TOYOTA SERVICE BULLETIN

Group: 09 No.: 08 Date: Oct, 18

## Model : Hiace

# Subject : Corrections to Repair Manual RM26T0E

# SPIRAL CABLE

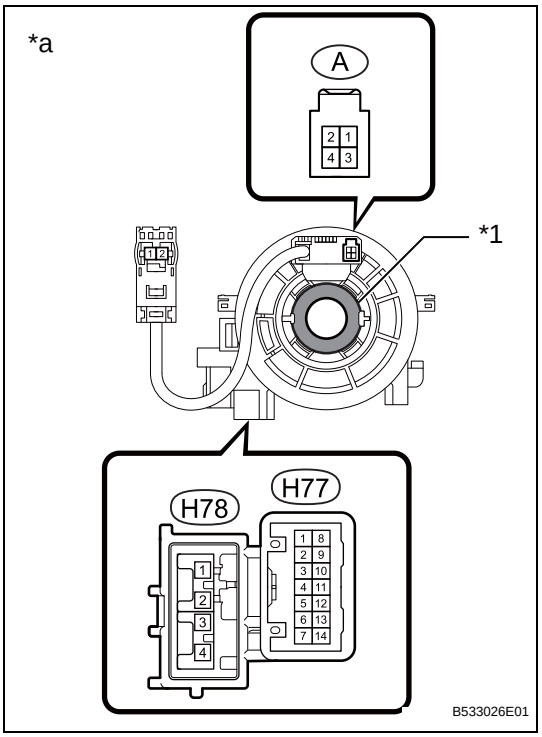
**When rotating the spiral cable sub-assembly, make sure to push on the interlock indicated in the illustration to release the interlock mechanism.**

[All Corrected]

(3) After setting the spiral cable sub-assembly to the center position, rotate the spiral cable sub-assembly 2.5 times clockwise, and measure the resistance as shown in the table below. Then rotate the spiral cable sub-assembly 5 times counterclockwise, and measure the resistance as shown in the table below.

(4) After setting the spiral cable sub-assembly to the center position, rotate the spiral cable sub-assembly 2.5 times clockwise. Then while rotating the spiral cable sub-assembly 5 times counterclockwise, measure the resistance as shown in the table below.

# SPIRAL CABLE

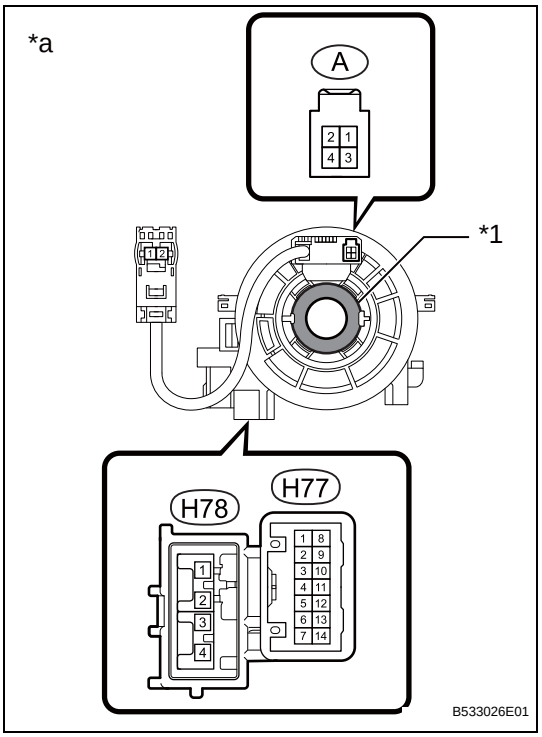
**When rotating the spiral cable sub-assembly, make sure to push on the interlock indicated in the illustration to release the interlock mechanism.**

[All Corrected]

(3) After setting the spiral cable sub-assembly to the center position, rotate the spiral cable sub-assembly 2.5 times clockwise, and measure the resistance as shown in the table below. Then rotate the spiral cable sub-assembly 5 times counterclockwise, and measure the resistance as shown in the table below.

(4) After setting the spiral cable sub-assembly to the center position, rotate the spiral cable sub-assembly 2.5 times clockwise. Then while rotating the spiral cable sub-assembly 5 times counterclockwise, measure the resistance as shown in the table below.

# SPIRAL CABLE

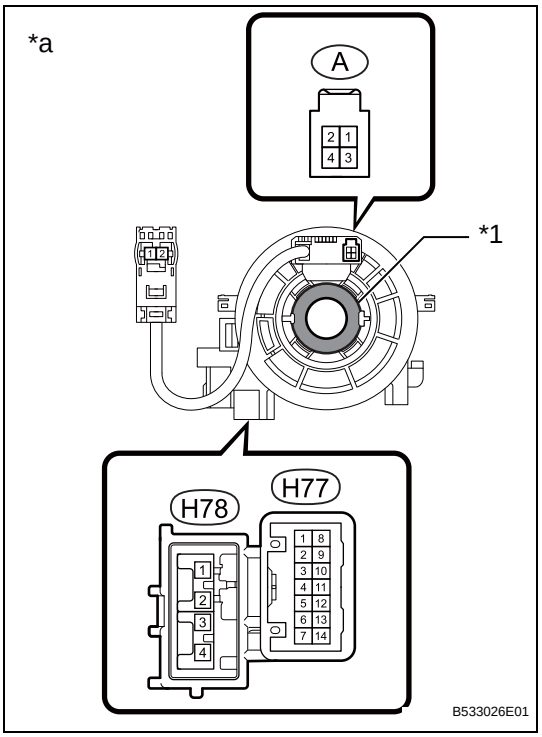
**When rotating the spiral cable sub-assembly, make sure to push on the interlock indicated in the illustration to release the interlock mechanism.**

[All Corrected]

(3) After setting the spiral cable sub-assembly to the center position, rotate the spiral cable sub-assembly 2.5 times clockwise, and measure the resistance as shown in the table below. Then rotate the spiral cable sub-assembly 5 times counterclockwise, and measure the resistance as shown in the table below.

(4) After setting the spiral cable sub-assembly to the center position, rotate the spiral cable sub-assembly 2.5 times clockwise. Then while rotating the spiral cable sub-assembly 5 times counterclockwise, measure the resistance as shown in the table below.

# SPIRAL CABLE

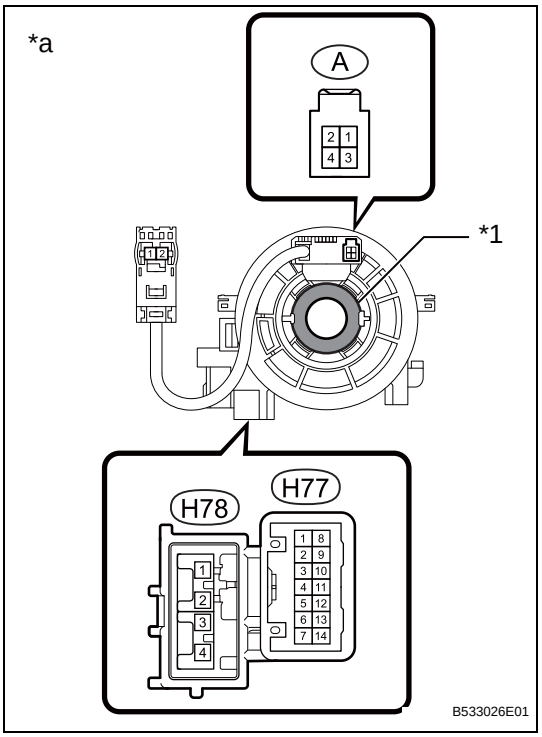
**When rotating the spiral cable sub-assembly, make sure to push on the interlock indicated in the illustration to release the interlock mechanism.**

[All Corrected]

(3) After setting the spiral cable sub-assembly to the center position, rotate the spiral cable sub-assembly 2.5 times clockwise, and measure the resistance as shown in the table below. Then rotate the spiral cable sub-assembly 5 times counterclockwise, and measure the resistance as shown in the table below.

(4) After setting the spiral cable sub-assembly to the center position, rotate the spiral cable sub-assembly 2.5 times clockwise. Then while rotating the spiral cable sub-assembly 5 times counterclockwise, measure the resistance as shown in the table below.
